Revision Number	Date	Drawn	Details of Issue / Revision
P02	19/05/23		Response to RFI
P01	25/04/22		Issued For Planning

Project Details:
 Dalguise
 Monkstown

Drawing Title:
 Proposed GA Plans - Block B

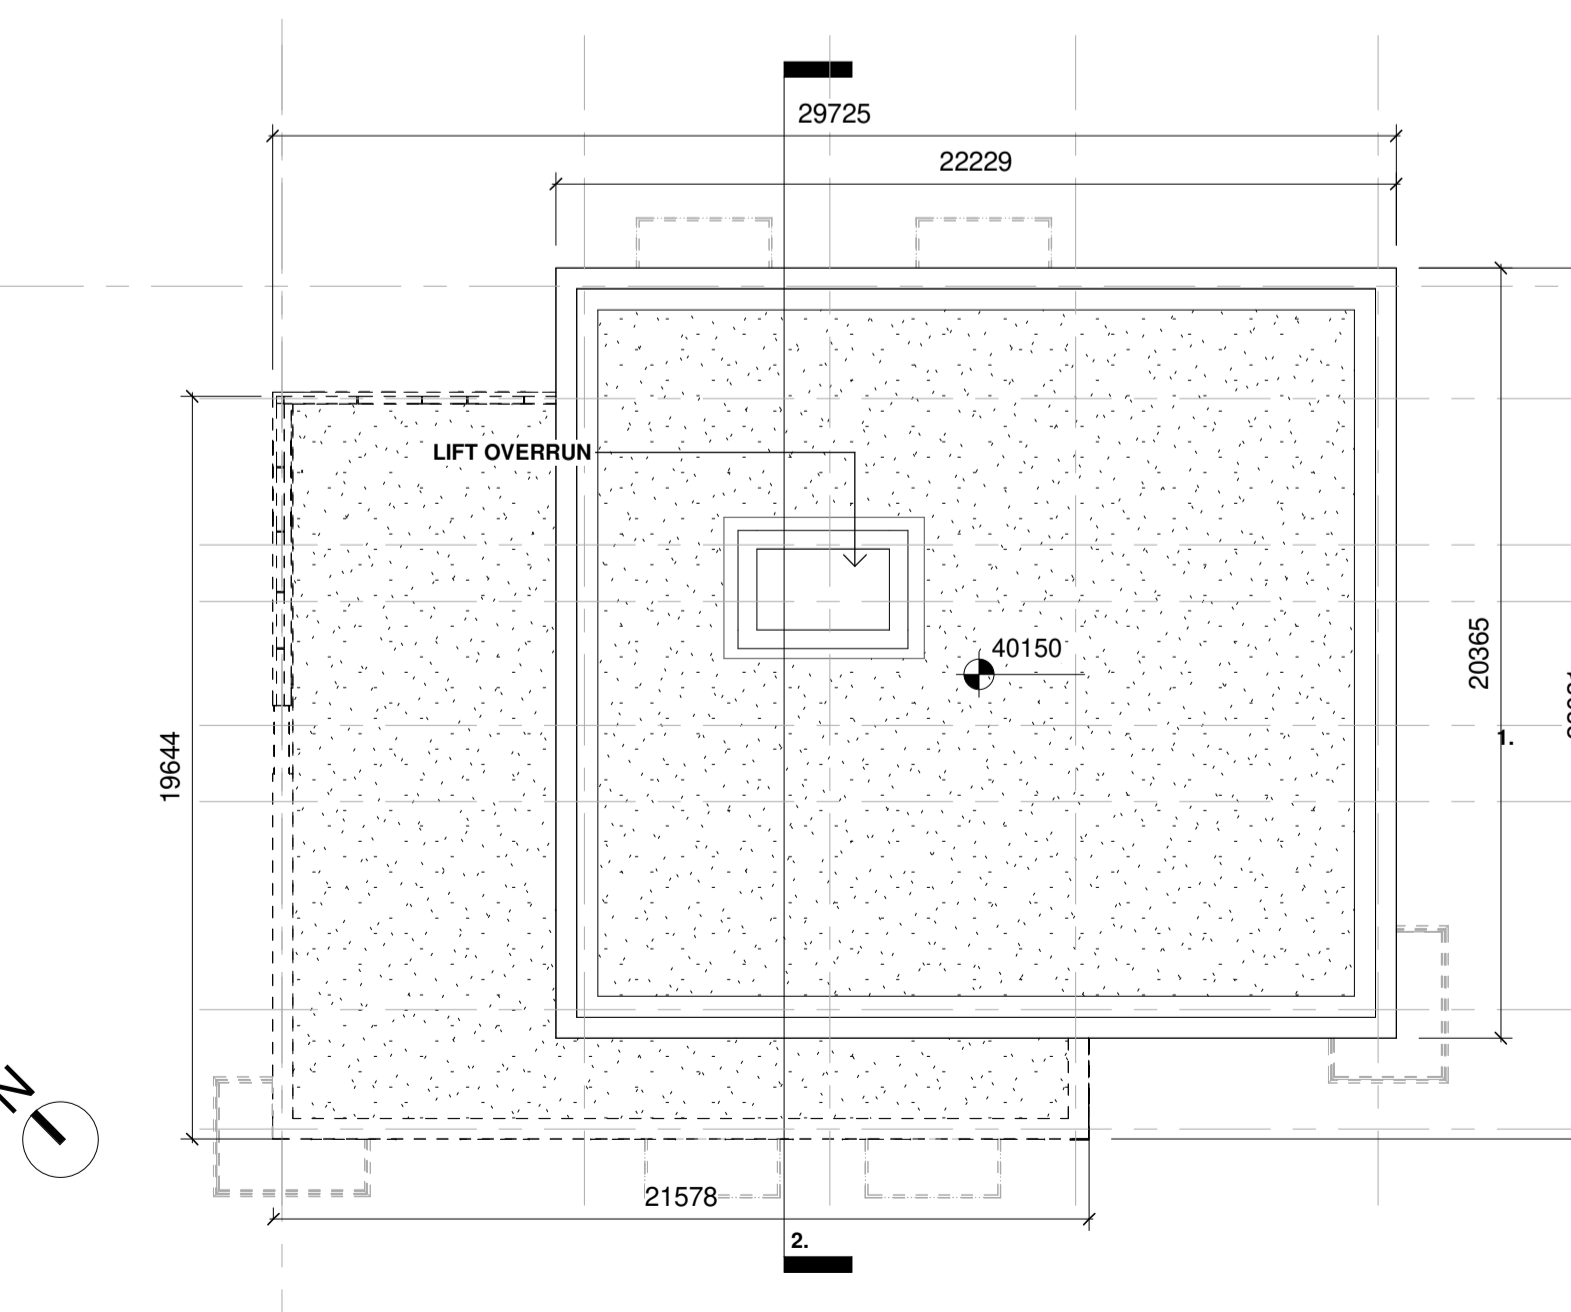
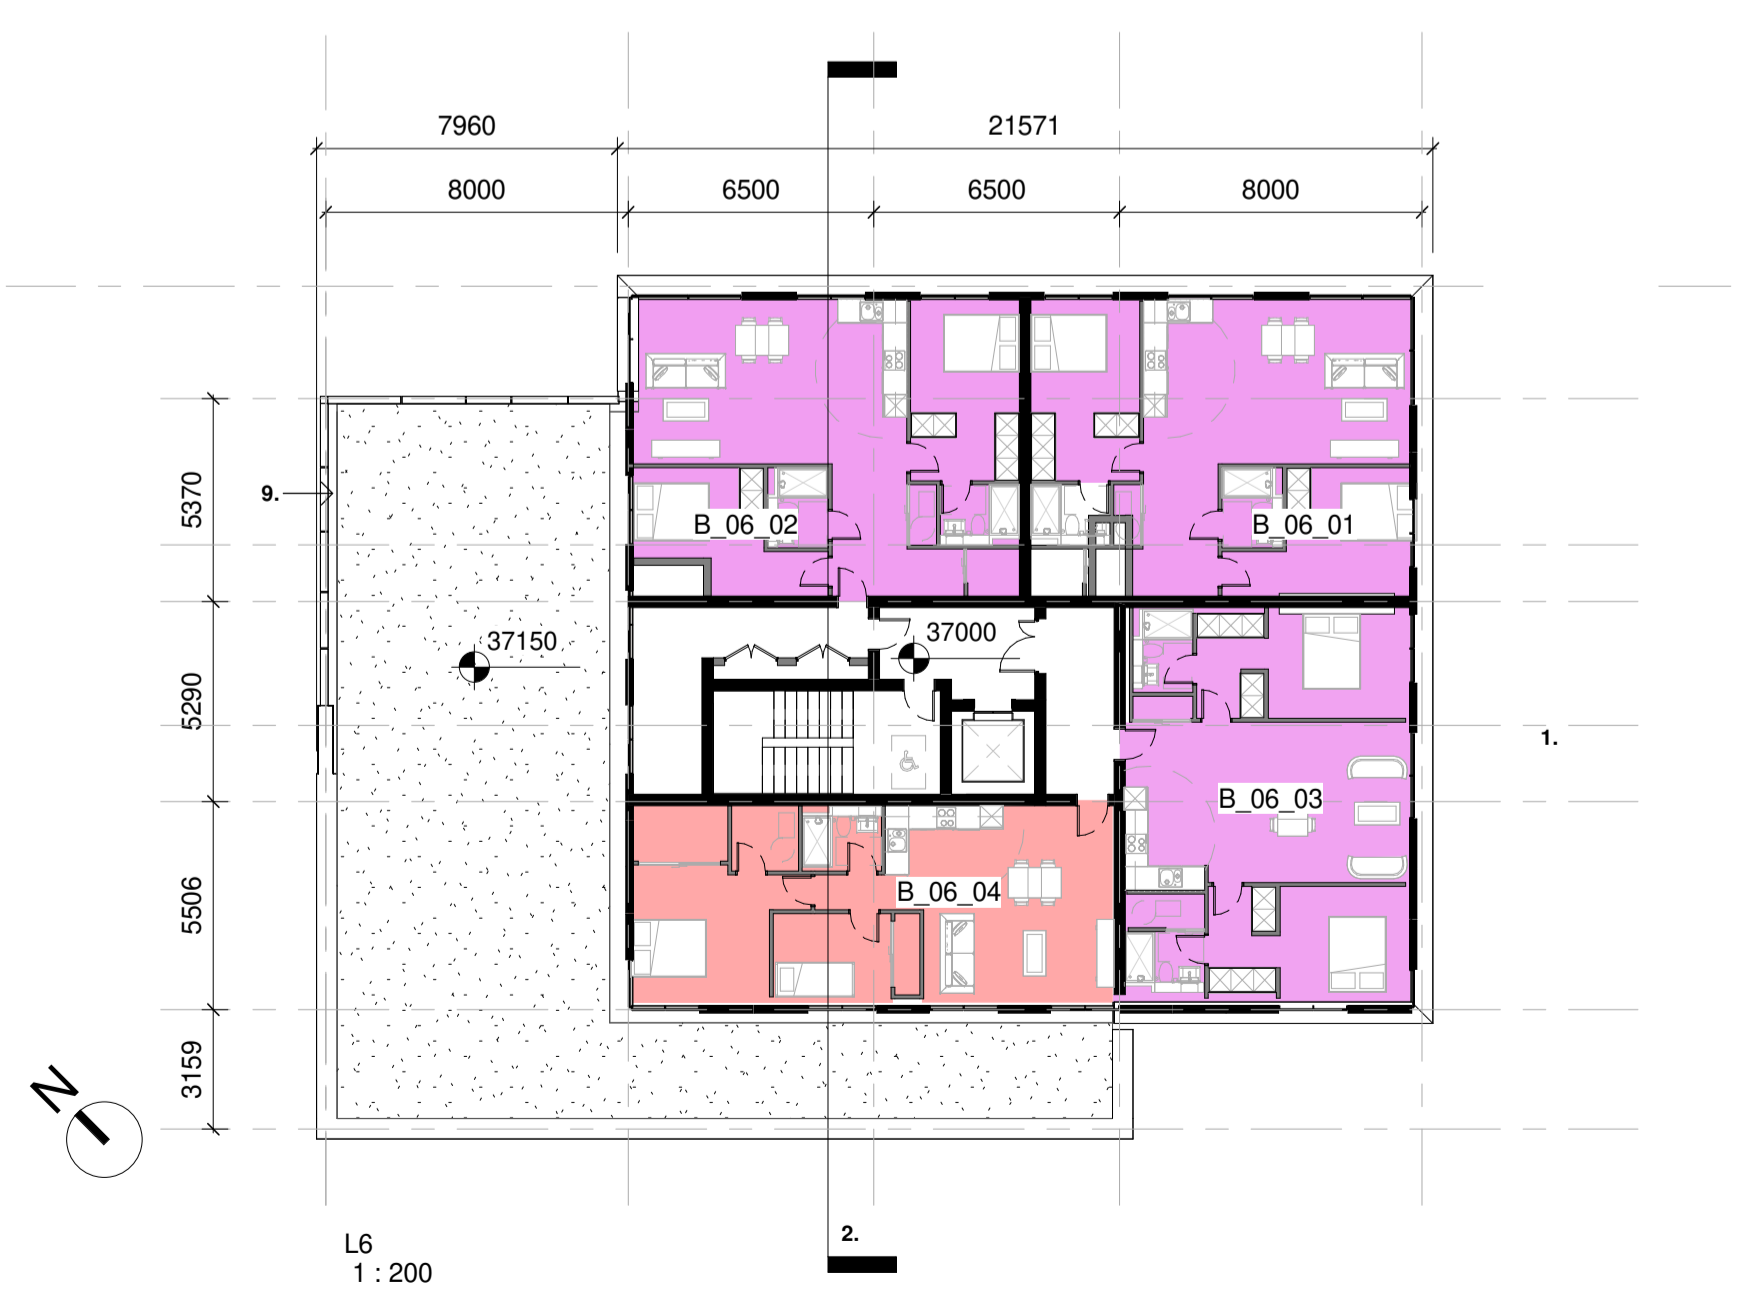
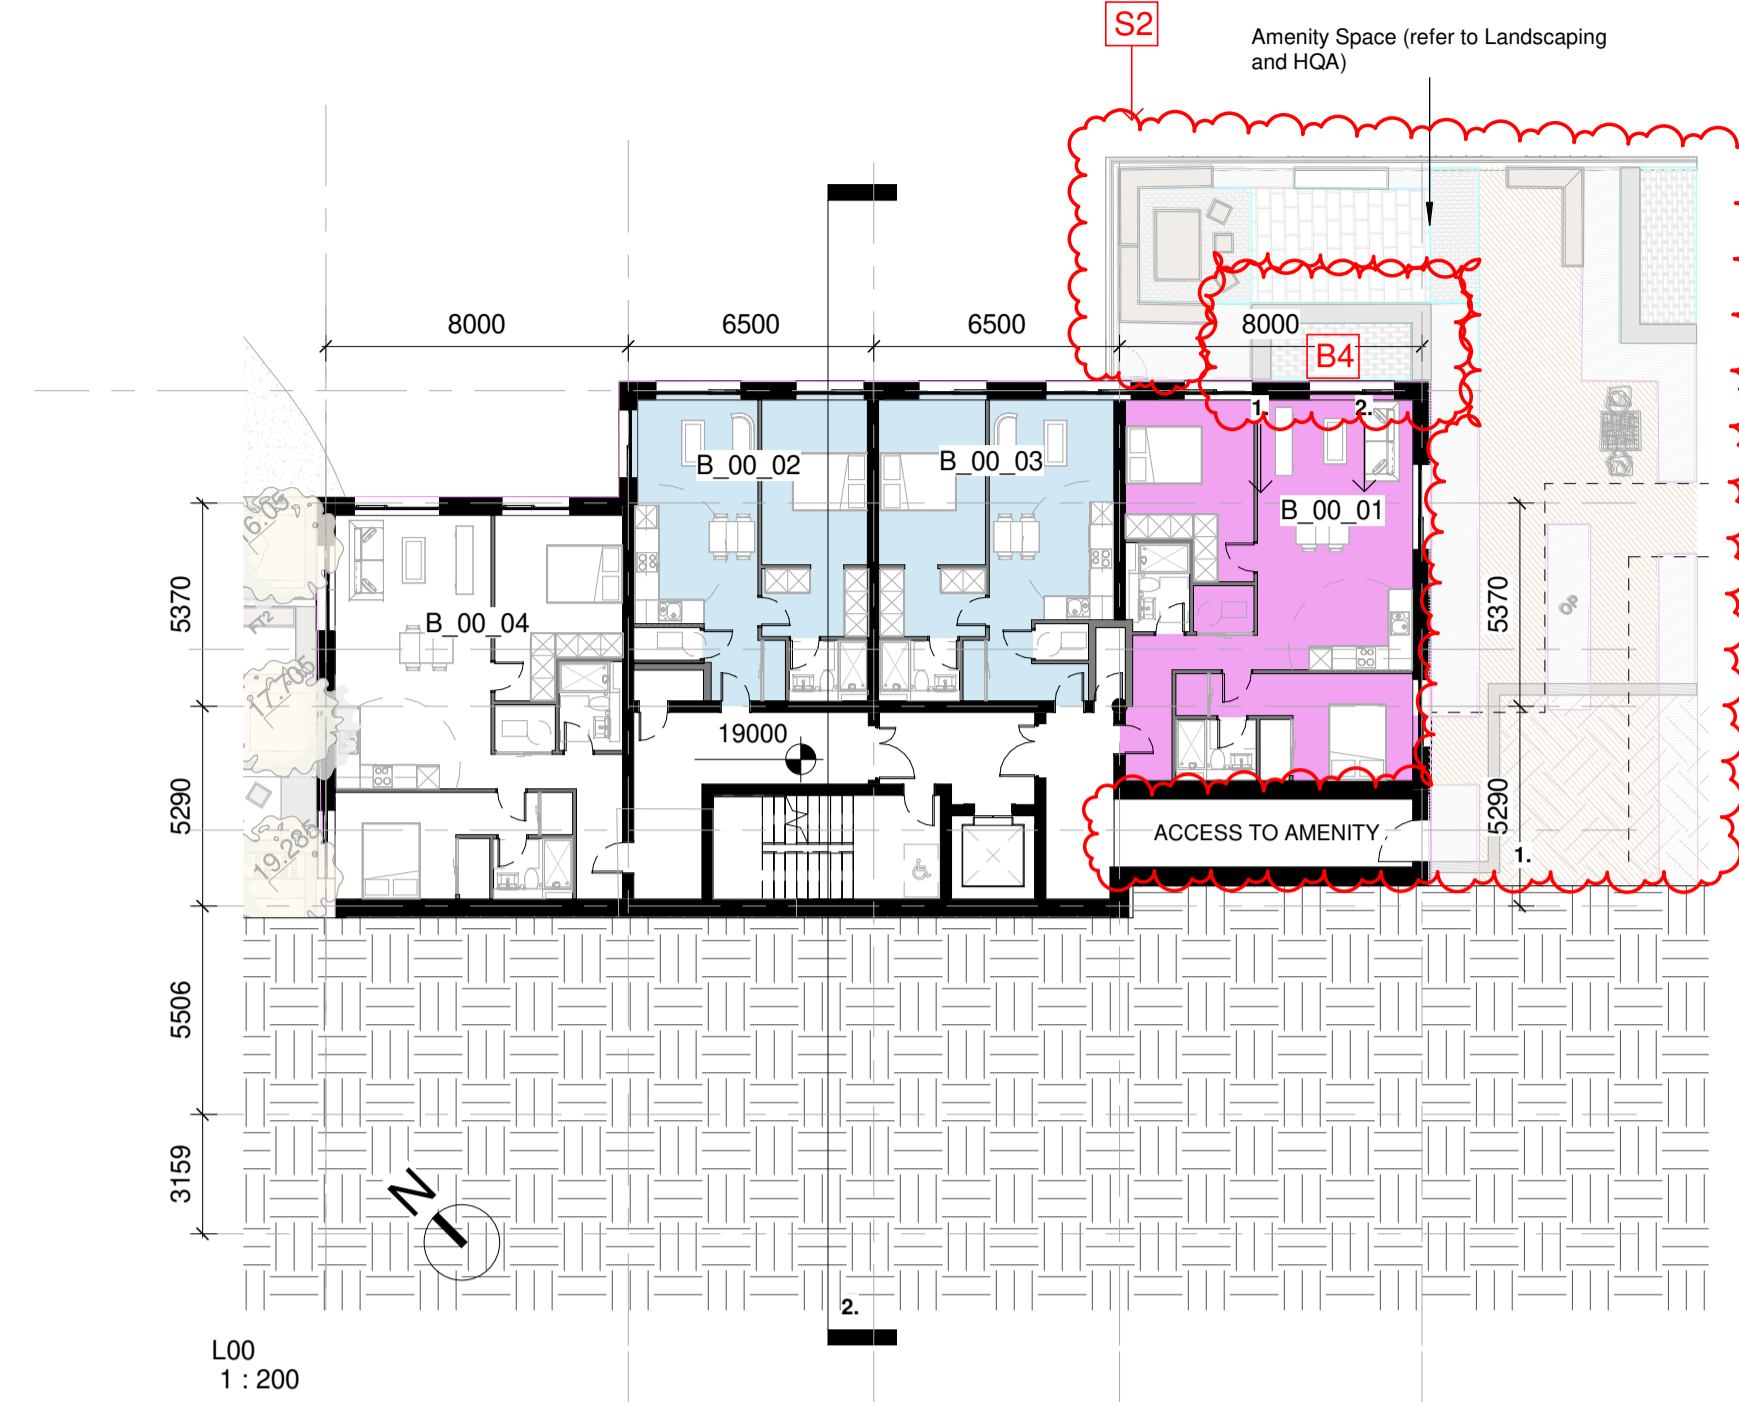
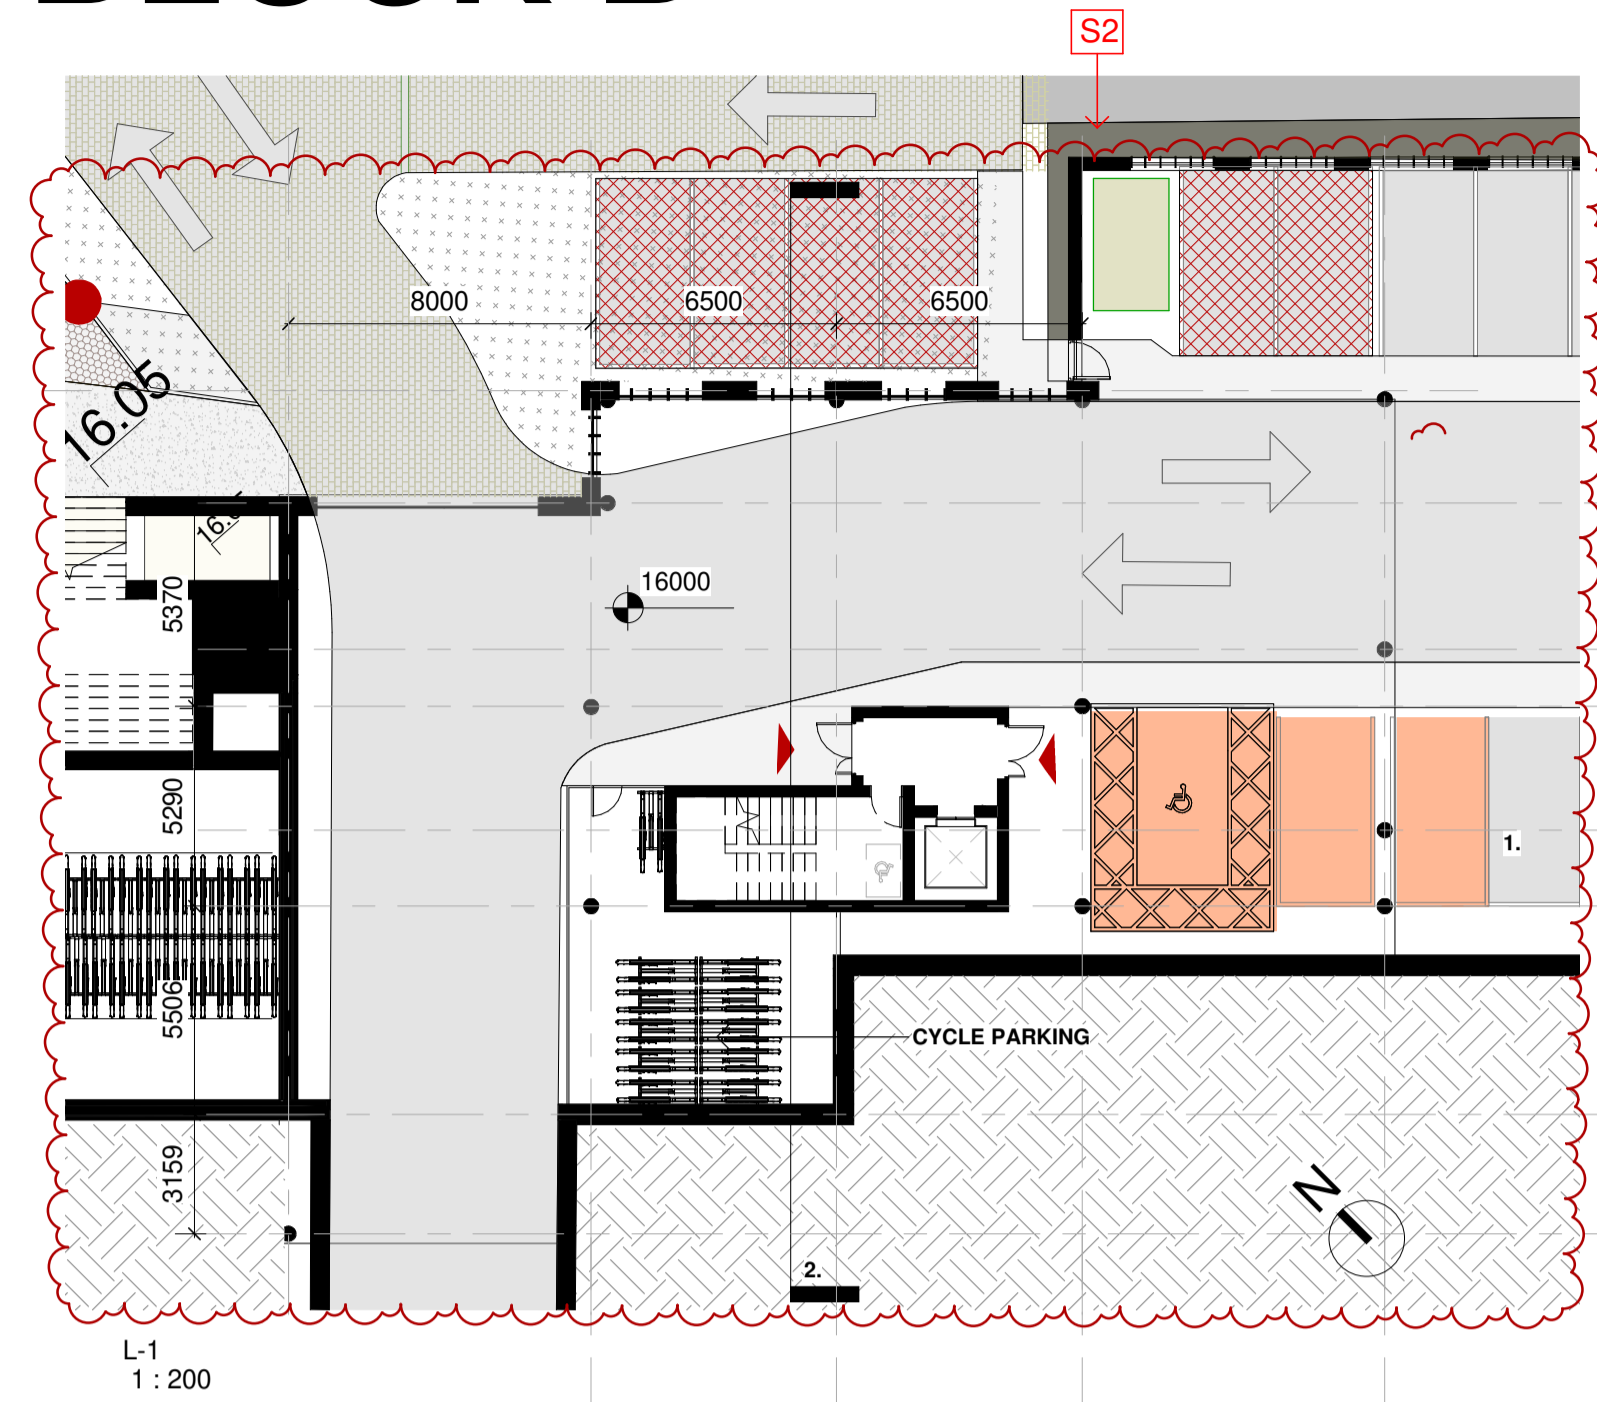
- REVISIONS**
- B1. Tonal Change at Penthouse level.
 - S2. Re-alignment of the Basement Car Park Entrance. The Entrance is now located underneath Block B.
 - S3. New external Amenity space added ground floor between Block B+C (Refer to HQA for area)
 - B4. New private balcony added to B_00_01 (Refer to HQA for area)
